1 Proposed baseline for D3.0:

79.3.2.5 PD requested power value

1 **79.3.2.6e PSE maximum available power**

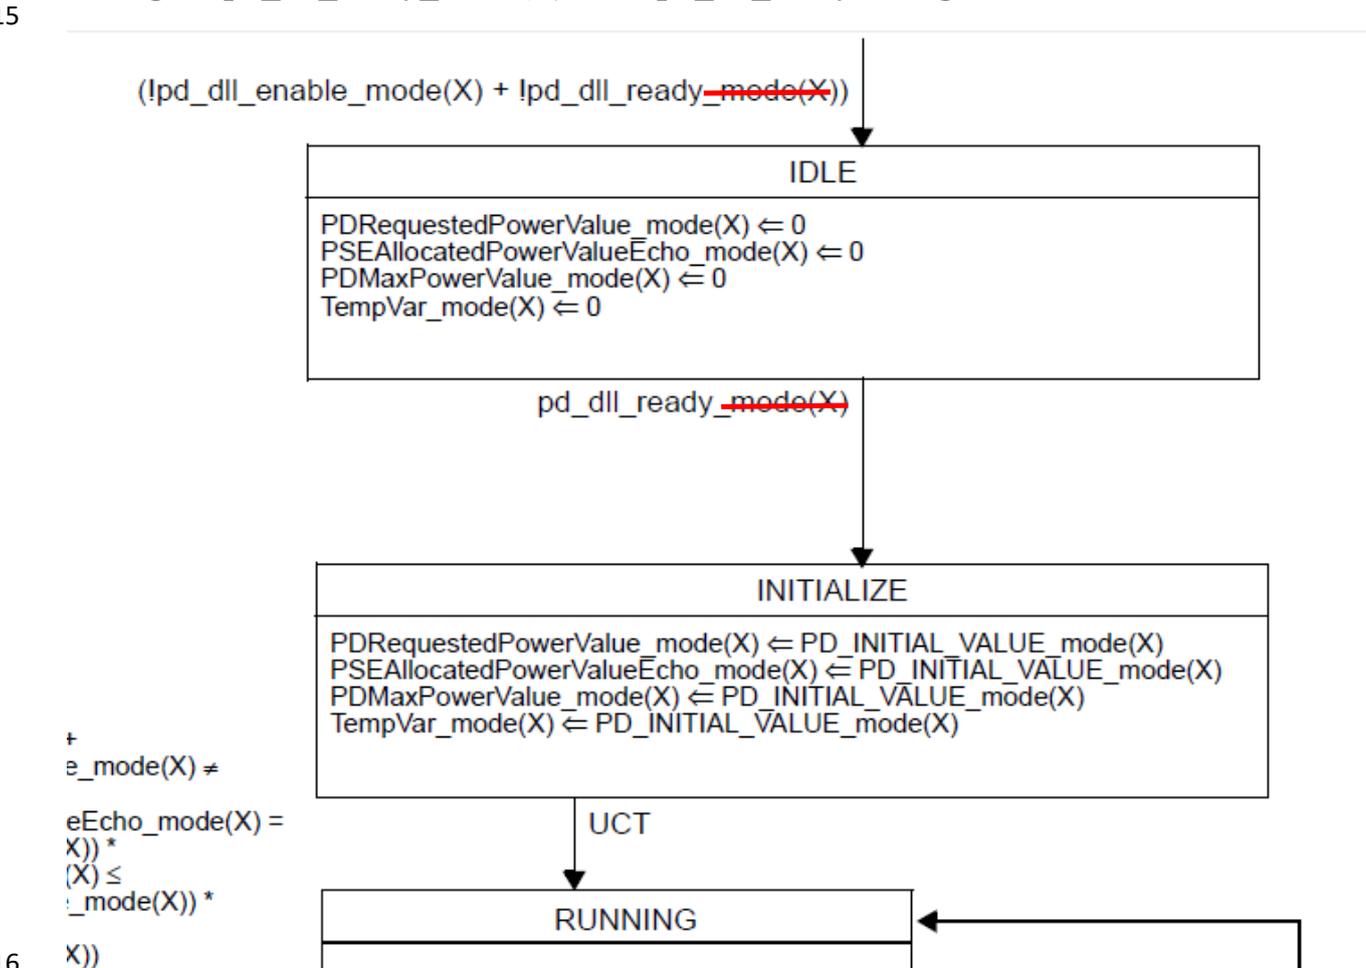
Not part of the baseline
 Power management for single signature and dual signature cares only for the total port power. Parts of the power management then use this power to allocate it per A and B fields. The following changes will allow us to get rid of the requirement of $Y=A+B$ in D3.0 and set $Y=0$ instead, when Type 3 /4 PSE operating over 4-pairs is connected to dual signature.

2 The PSE maximum available power field shall contain the highest power the PSE can grant as defined in Table 79–6e [to the](#)
 3 [port when supporting single-signature PD or dual-signature PD PD](#). The PSE shall set the value of this field taking available
 4 power budget and hardware capabilities into account.
